# APPLICATION FOR BUILDING PERMIT

Application Number:	512	Date:	05/17/2021
Job Location:	42 BUTTERWOOD LANE EAST	Parcel ID:	2.130-67-13
Property Owner:	Devina Foley	Property Class:	1 FAMILY RES
Occupancy:	One/ Two Family	Zoning:	
Common Name:

**Review Date** 05/25/2021

This Department has received your last submitted plans for the noted project and offers the following comments:

1 BASEMENT FLOOR PLAN: PROPOSED  
1/4" = 1'-0"

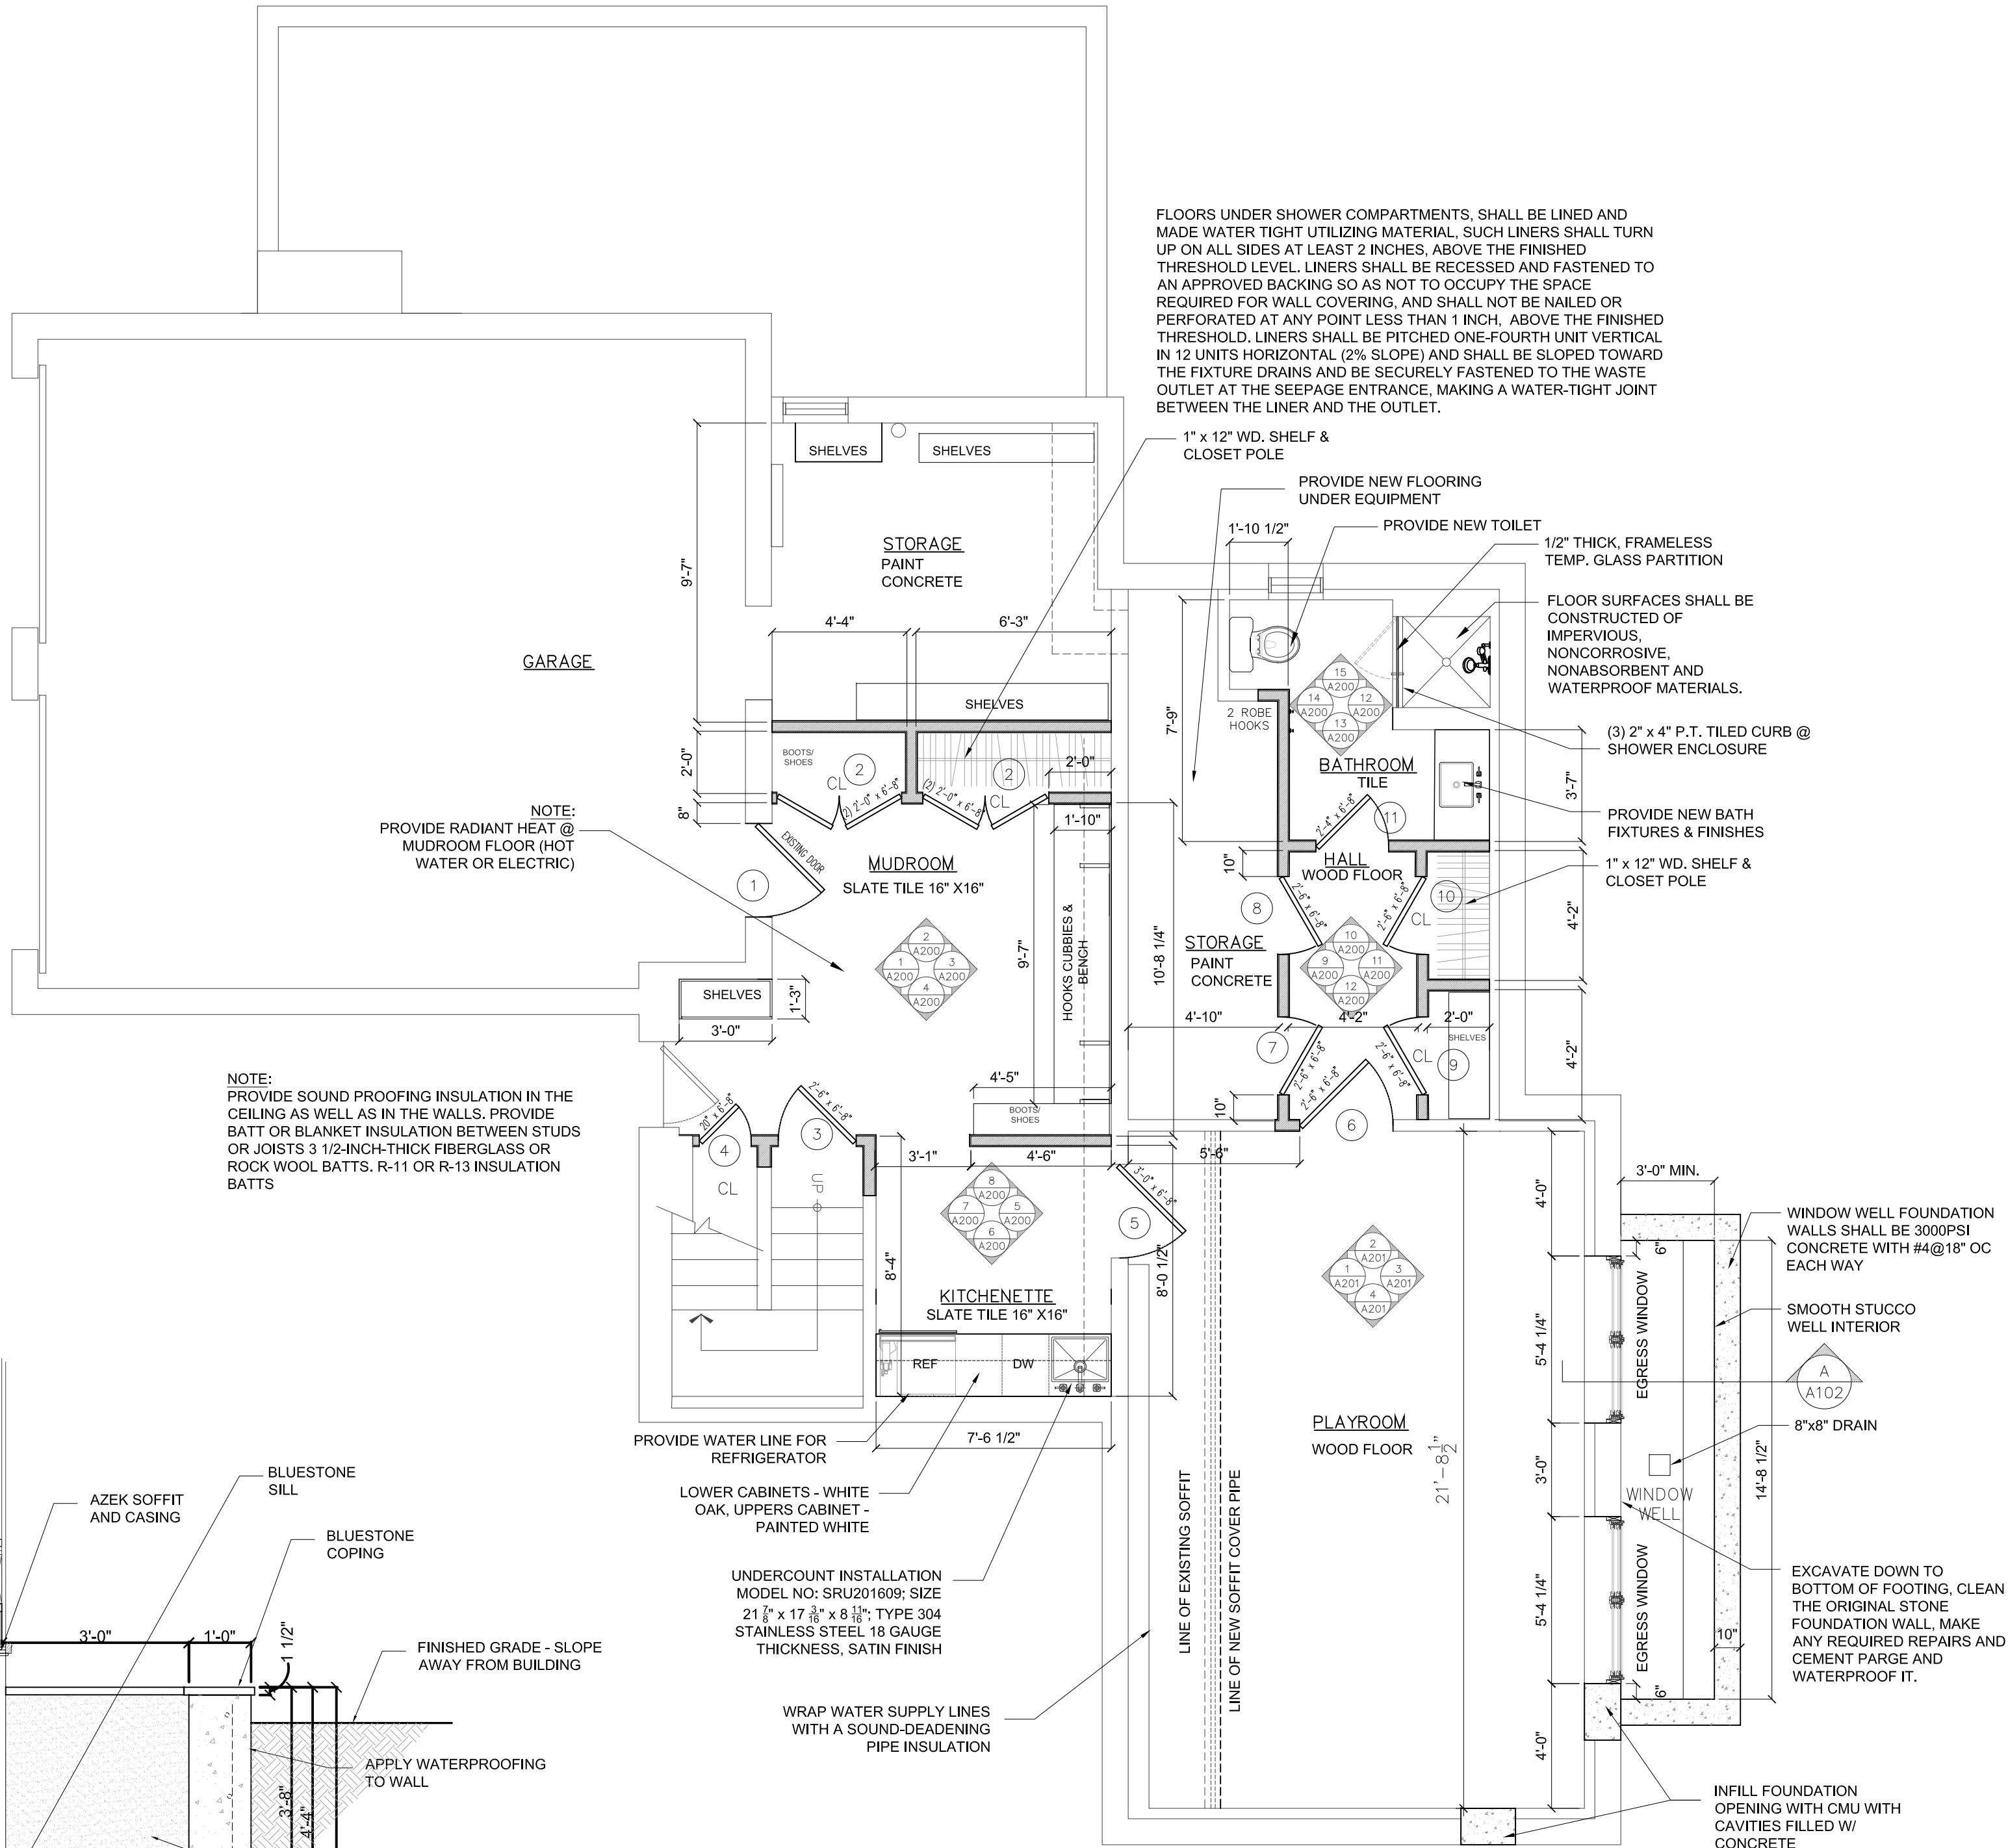
Please submit (3) copies of the entire elevation wall drawings for which the basement egress windows/window well are being proposed, by June 7, 2021 so that we can place you on the Architectural Review Board Agenda. Also, please submit the signed second page of the Application for Building Permit.  
Further review required.
